# Airworthiness Directive Schedule

### Taylorcraft BC12-D

29 May 2008

**Figure 1**

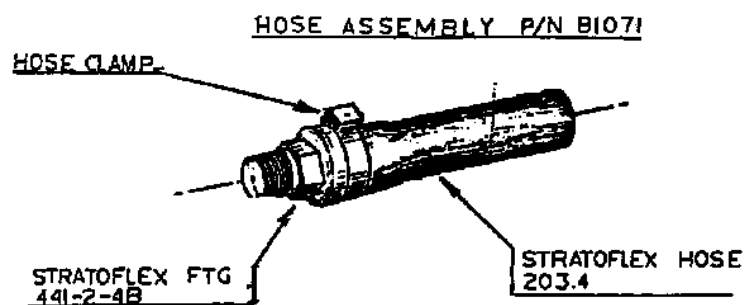
**DCA/TAYLOR/1 Canceled – DCA/TAYLOR/8 refers****Effective Date:** 28 March 2008**DCA/TAYLOR/2 Oil Pressure Gauge Hose – Inspection and Replacement****Applicability:** Model BC12-D aircraft, all S/N**Requirement:** To prevent loss of engine oil and the possibility of engine failure, inspect the oil pressure gauge hose assembly at the engine and establish whether hose assembly P/N B7071 is fitted to the aircraft per figure 1 below.

If the oil pressure hose assembly is not the type illustrated in figure 1, no further action is required.

If the oil pressure hose assembly fitted to the aircraft is the type illustrated in figure 1, replace with a new hose assembly P/N B7071 identified by Taylorcraft with a "T" stamped on a wrench flat on the hose assembly brass fitting.
